ADDENDUM NO. 2

DFS TERMINAL, HANGAR, AND APRON DEVELOPMENT

CITY OF DEFUNIAK SPRINGS, FLORIDA

Addendum Date: February 25, 2022

G-6

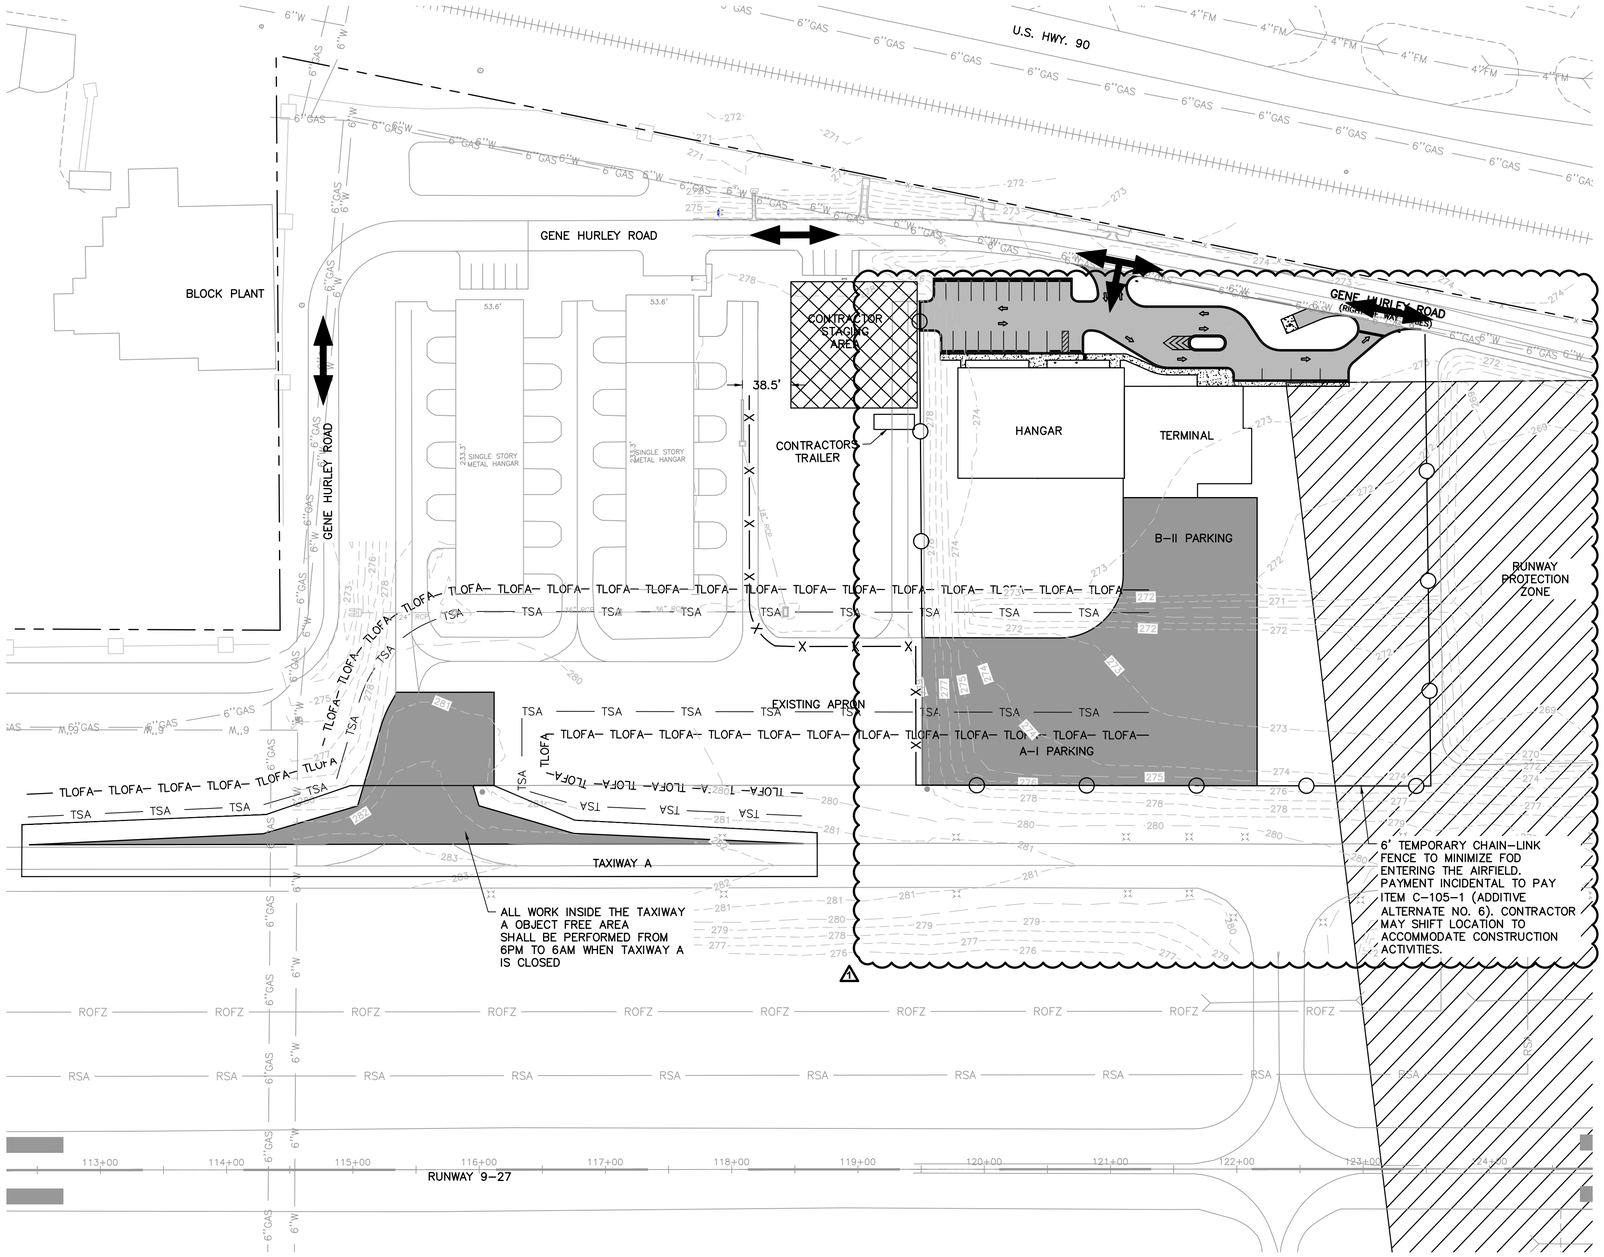
RESPONSE: The temporary fence will be depicted on Sheet G6 in Addendum No. 2.

SHEET NUMBER
G0.04

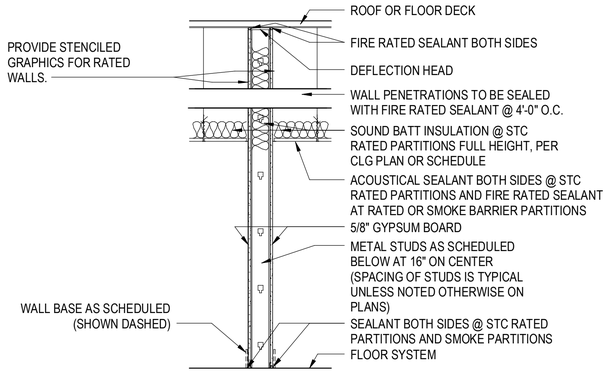
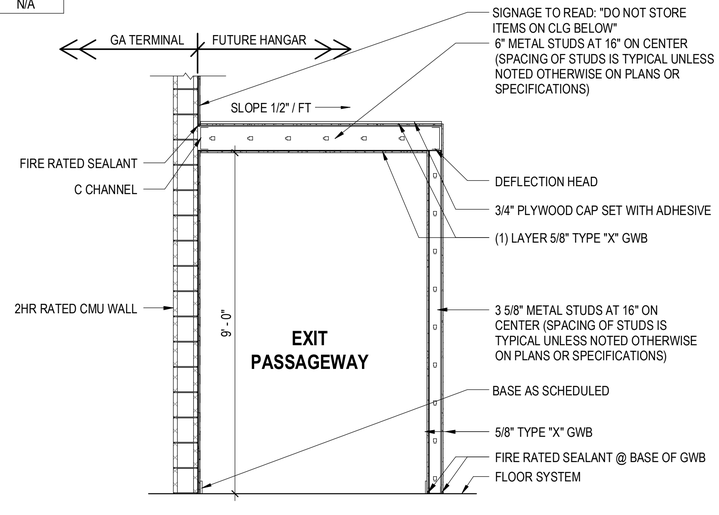
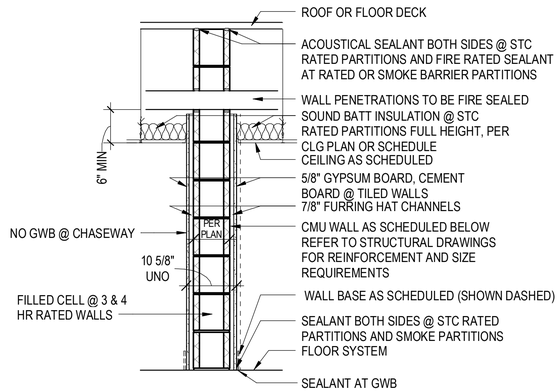
1.	G0.04 – WALL TYPES	• Added wall type 1A0.3
2.	A-002 – TYPICAL ADA DETAILS	• Cleaned up the drinking fountain graphics.
3.	A-102 – 1ST FLOOR PLAN	• Corrected restroom Chase 116A's room number. • Corrected dimensions at Door 113A to provide 1'-6" pull-side clearance. • Clarified the note at walls in Rooms 118, 119 and 120 to read "fire rated". • Added corner guards at doors 103D and 113A.
4.	A-103 – CLERESTORY PLAN	• Corrected parapet height to 24" high.

1 BUILDING SECTION
SCALE: 1/4" = 1'-0"

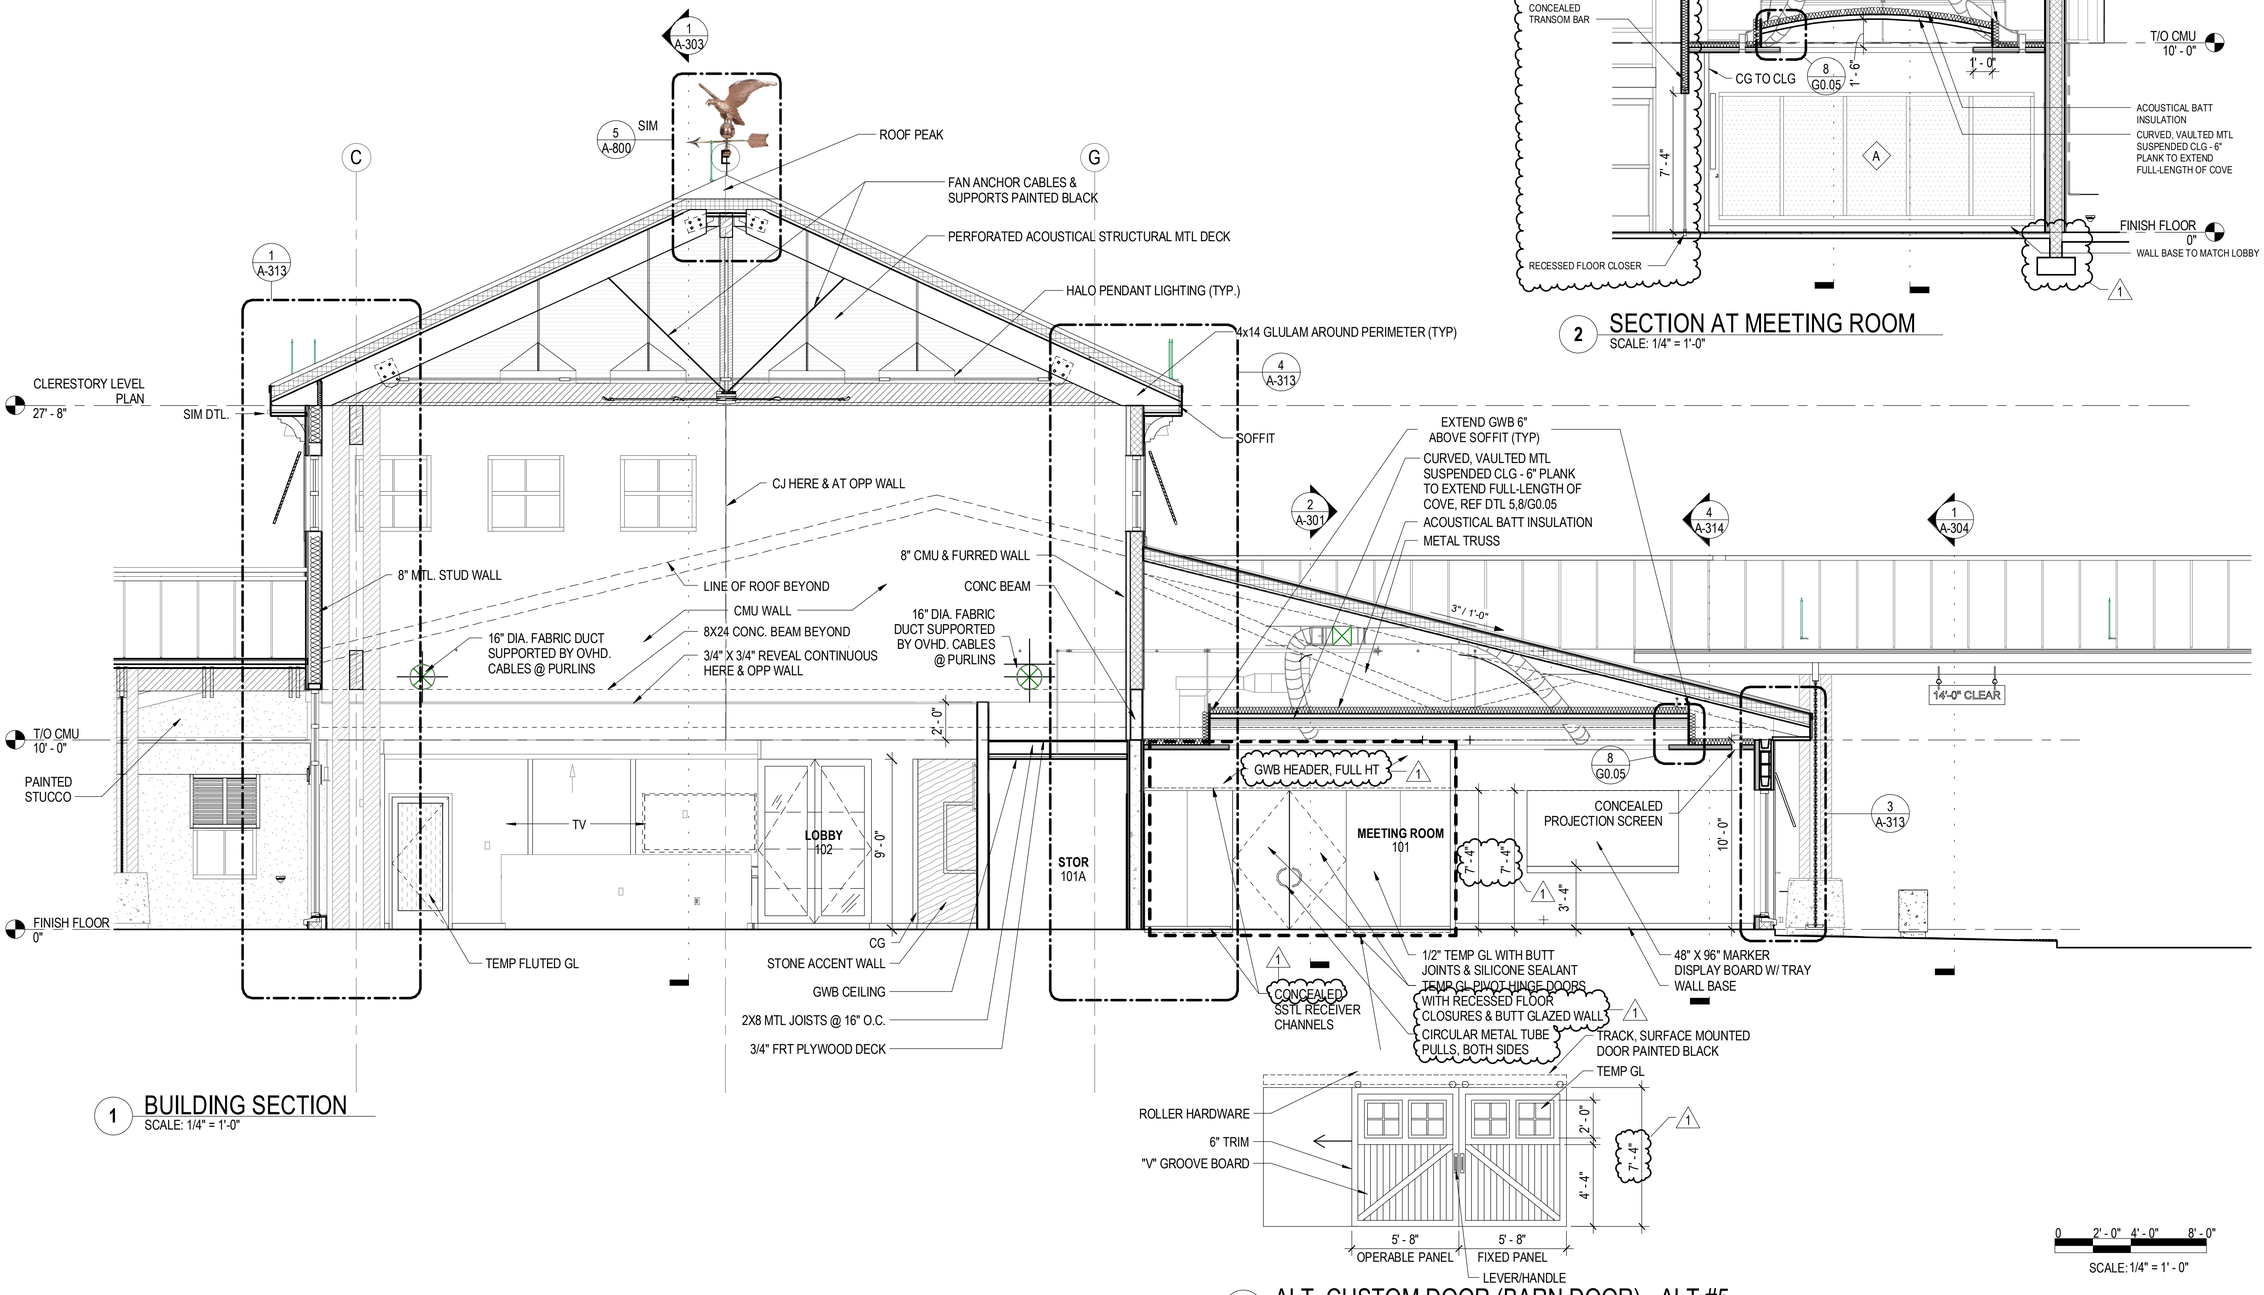
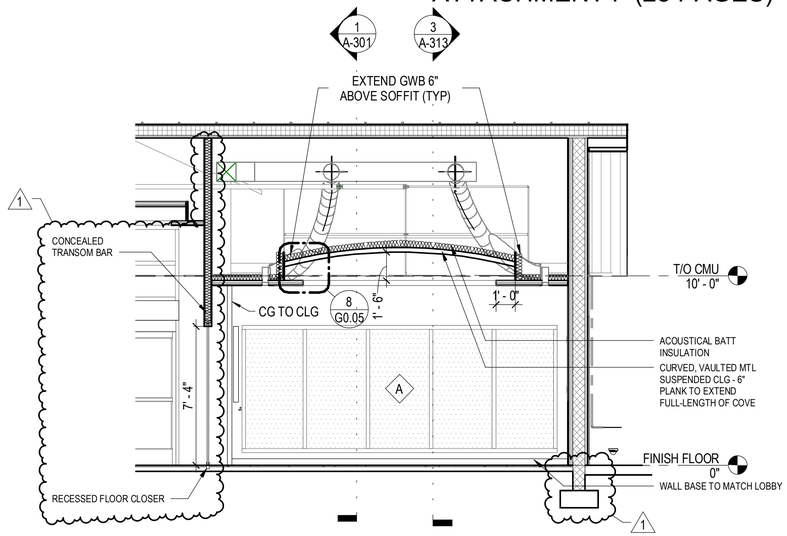
9.	A-301 – BUILDING SECTIONS	• Detail 1:
		  o Revised the Meeting Room's butt glazed wall to stop at 7-4" and receive a gypsum header. The barn door alternate is now 7'-4" as well.
		  o The stainless steel receiver channels are now recessed at the drywall header and are flush at the sill.

○ Revised the door pulls to be circular metal tube pulls. Refer to the added specification 08450 ALL-GLASS ENTRANCES AND STOREFRONTS. • Detail 2: ○ Updated graphics to depict foundations. ○ Wall common to Conference Room and Lobby updated to reflect a 1A0.3 type wall up to deck with sound batt insulation.

A-302

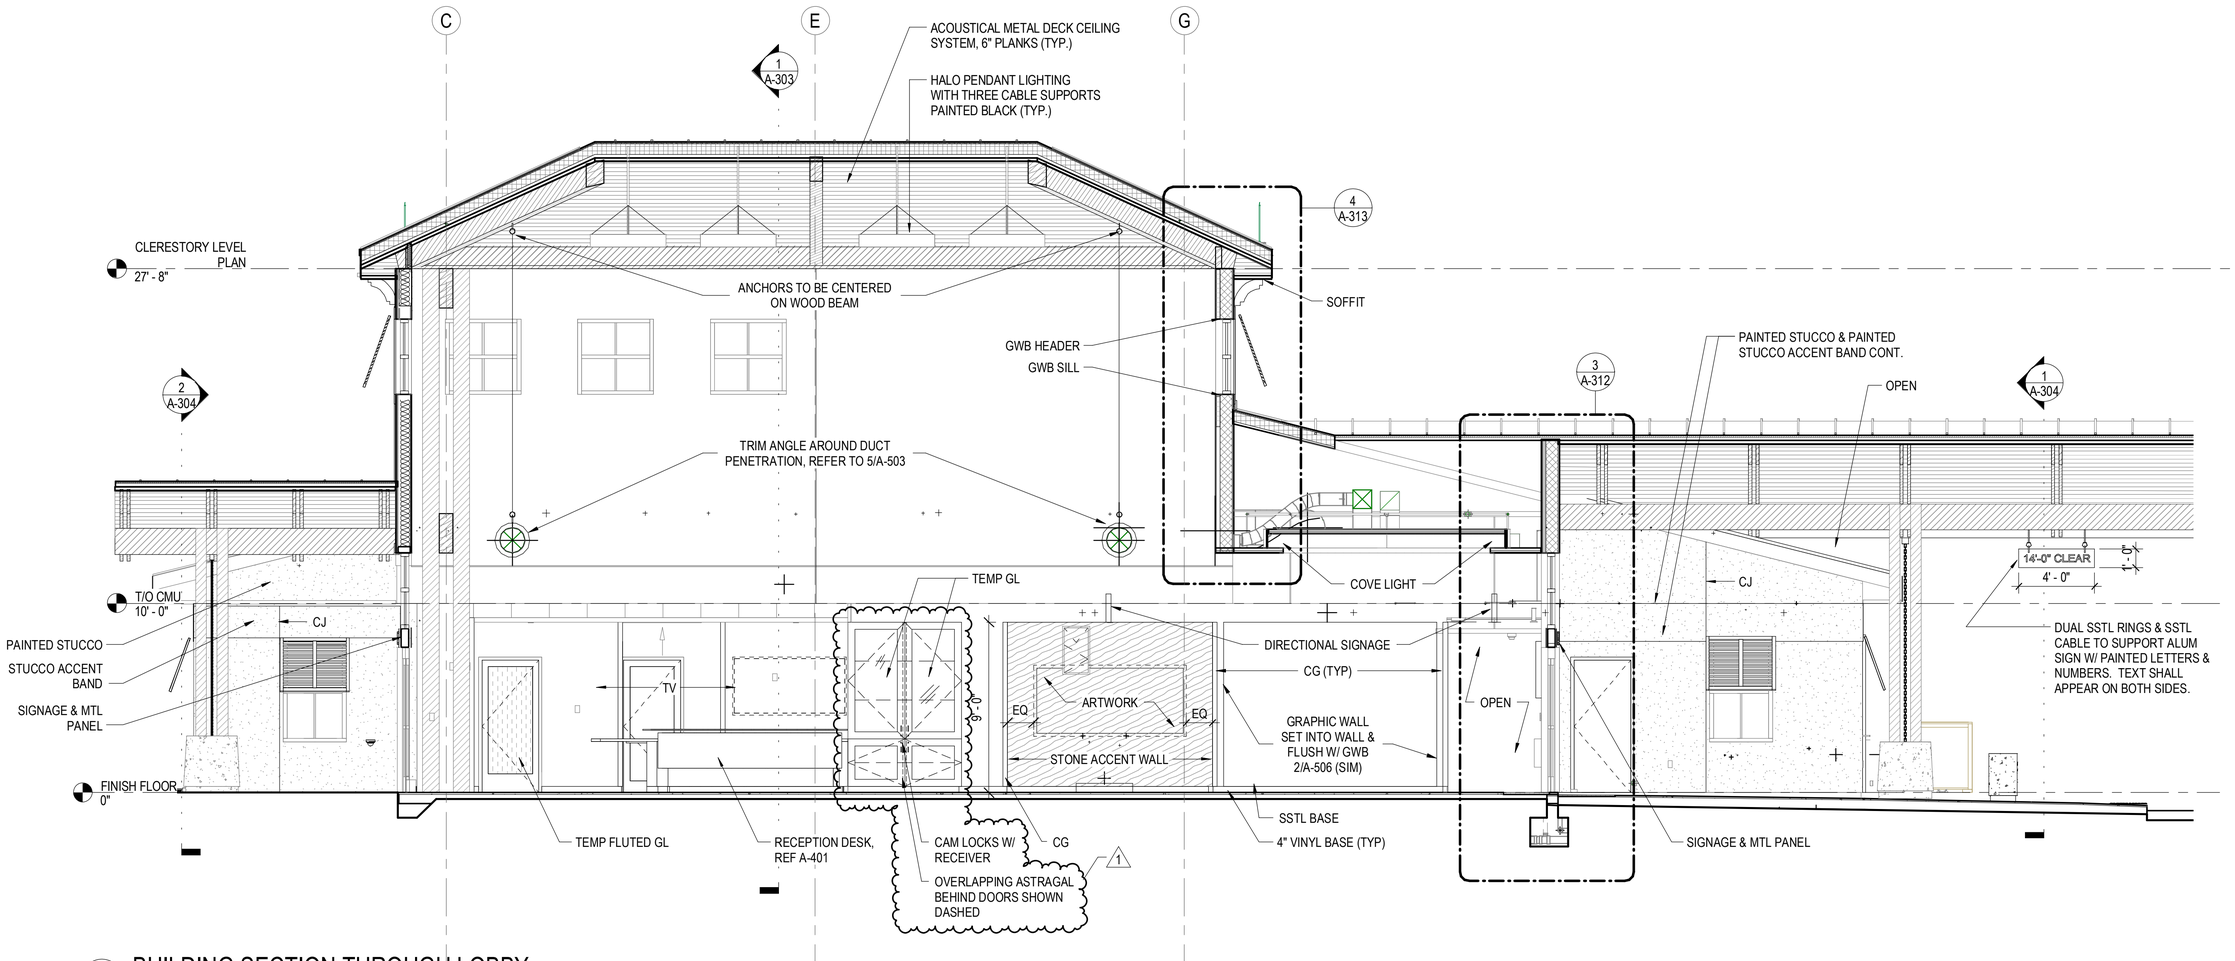
10.	A-302 – BUILDING SECTIONS	• Revised display cabinet elevation to match detail 2/A-704. Refer to updated detail 2/A-704 for additional updates.
11.	A-303 – BUILDING SECTIONS	• Corrected tile pattern alignment at shower area.

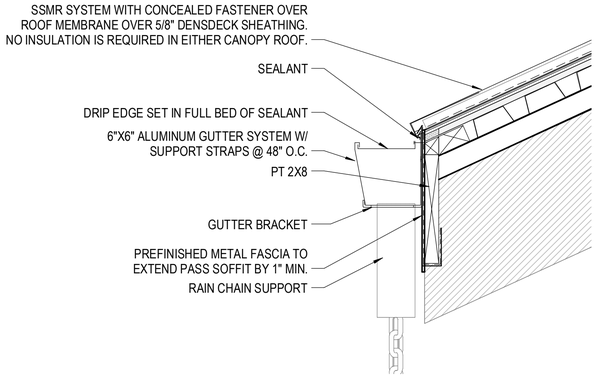
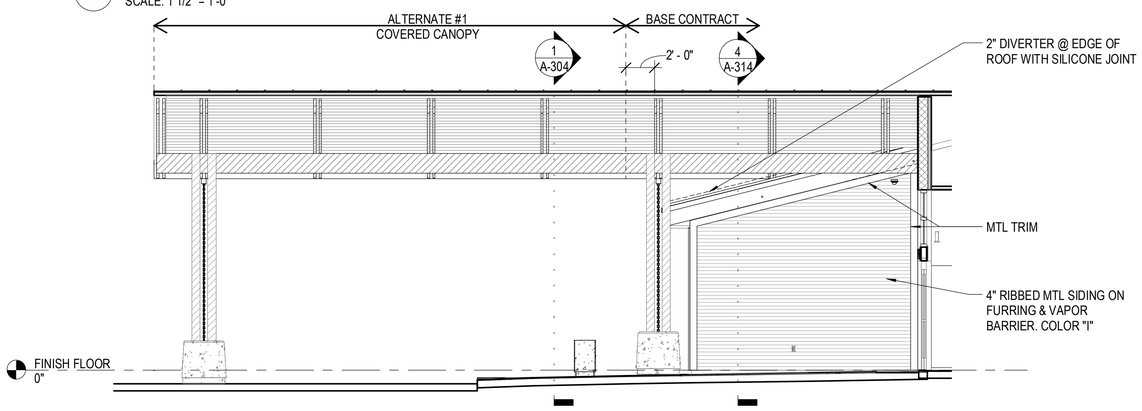
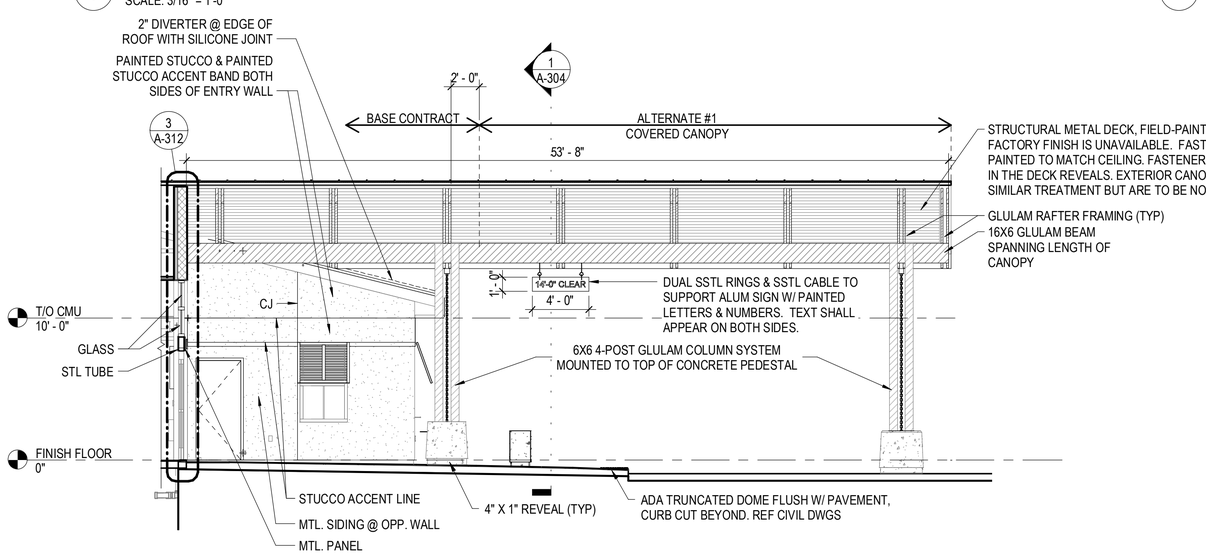
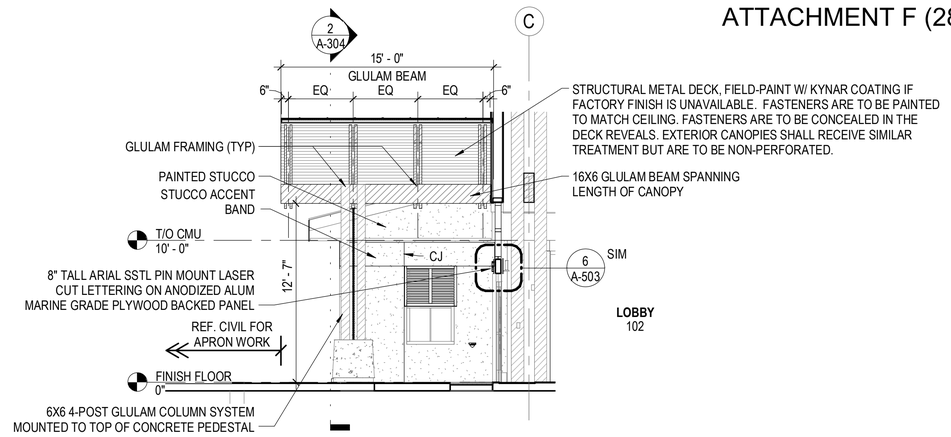
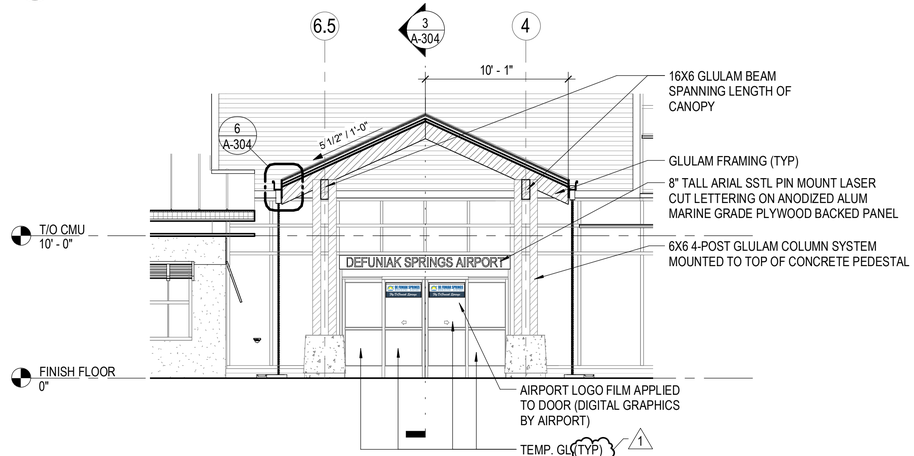
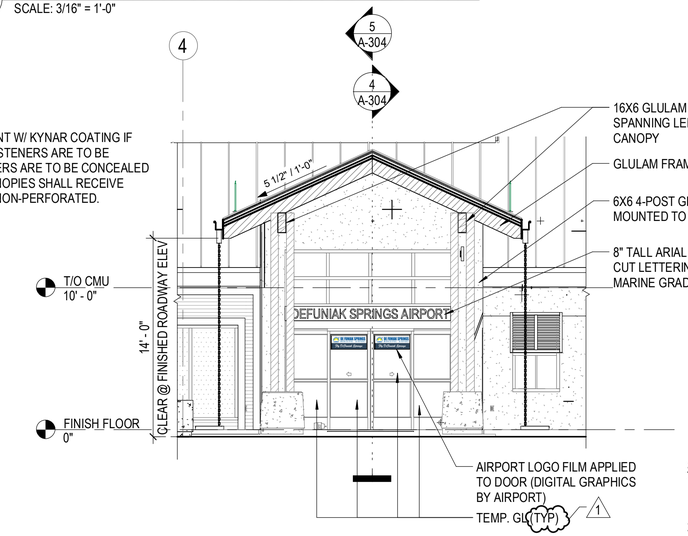
12.	A-304 – CANOPY SECTIONS	• Details 1 & 2 ○ Added “TYP” (typical) to the tempered glass door notes.
13.	A-313 – WALL SECTIONS	• Detail 3 ○ Corrected conflicting header graphic.
